ADVISORY

No. 99-8

Red Stator – 6 thru 25 (2S)

6 thru 25 (2 Stroke)

Flywheel

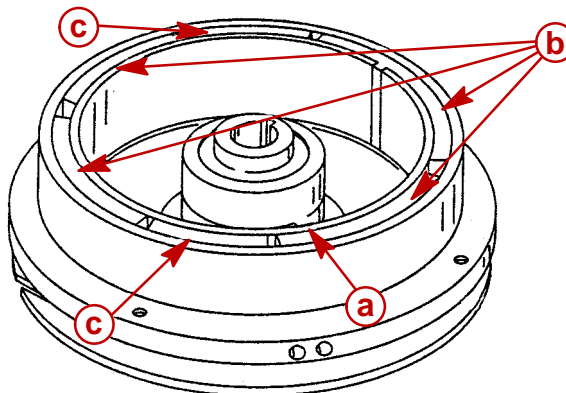
The new flywheel has four magnets instead of two. A stainless steel retaining ring is installed to protect the magnets on commercial models. The tachometer dial setting should correspond with 5 positive pulses (10 pole). Refer to "Tachometer Setting" following.

- a** - Retainer Ring – Commercial Models
- b** - Magnets
- c** - Spacers

Ignition Stator

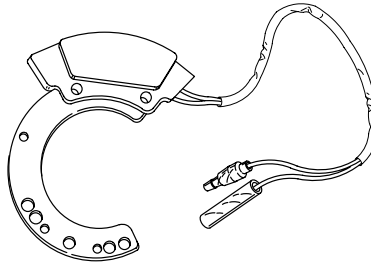
The new red colored stator has a single ignition bobbin. The stator bobbin wire is thicker and has the same bobbin as 30-125 (2 Stroke) models.

Switch Box

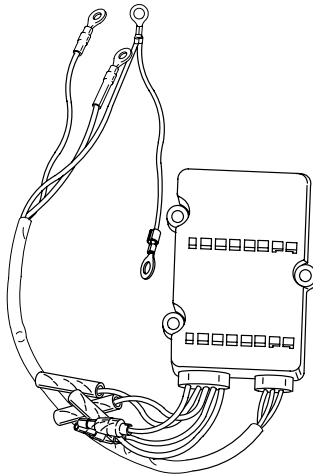
The new switch box contains two CDM circuits and regulates incoming ignition stator voltage to approximately 300 volts. The 855713A3 (marked 855713A1) switch box on commercial and jet models has a 6200 rpm limiter. The 855713A4 (marked 855713A2) switch box does not have a rev limiter.

Models with rev limiter: 15ML "S15", 10 Marathon/Sea Pro, 15 Marathon/Sea Pro, 15 Marathon XD/Sea Pro XD, 20 Jet, 25 Marathon/Sea Pro.

Admiral, Flagship, International, and Commodore gauges

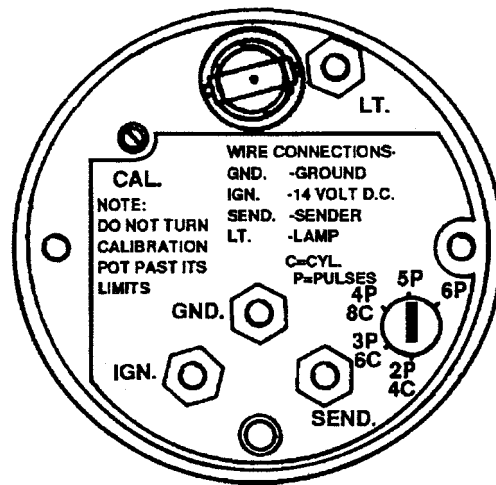
The tachometer dial setting is position 3 on 79-817030A1 QSI gauge and position 5P on Admiral, Flagship, International, and Commodore gauges. The new red stator system generates 5 positive pulses (10 poles) per crankshaft revolution. The setting for 1998 and prior models is 3 on QSI gauges except 79-817030A1 and 4P on Admiral, Flagship, International, and Commodore gauges.

1998 and Prior	1999 and Newer
All QSI except 79-817030A1 Dial setting 3	QSI 79-817030A1 Dial setting 3
All gauges except QSI Dial setting 4P	All gauges except QSI Dial setting 5P
4 Positive Pulses	5 Positive Pulses
8 Pole	10 Pole
